MEMORANDUM

From:	Gordon Adam Development Control		
Service	WBC Highways	App No:	242421
Address:	School Road, Arborfield Cross.		
Proposal:	Outline application for the proposed erection of up to 95 No. dwellings, together with open space and associated works. (All matters reserved except for means of access).		
Type of Development:	Major Dwellings (10+)		
Site Visit Made:	Yes/No

Access

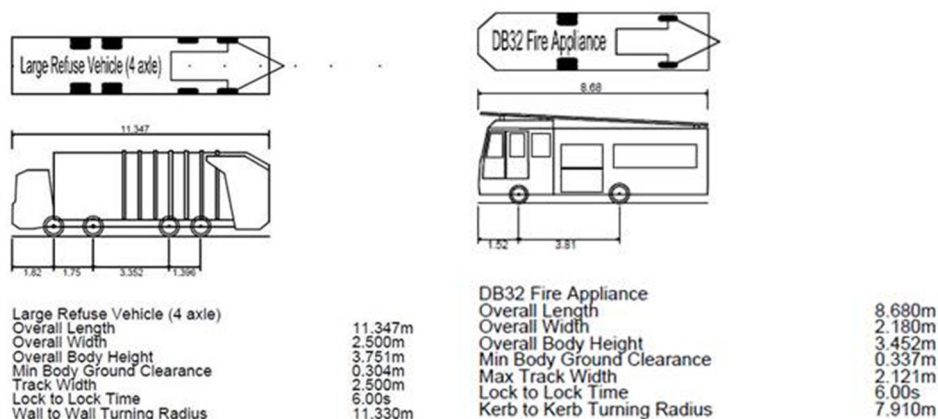
14. It is proposed that School Road would be re-aligned to continue into the site which is welcome. However, the submitted plan would need to be improved to reflect this.
15. It is proposed that there would be a 2m pavements on both sides of the road which is welcome.
16. In addition, it is proposed that an emergency access would be provided onto Cole Lane. This would be 3.7m wide and also provide a pedestrian and cycle access which is welcome.
17. This access would need to be provided with removable bollards, and these would need to be included in any detail design submitted as part of any reserve matters application.
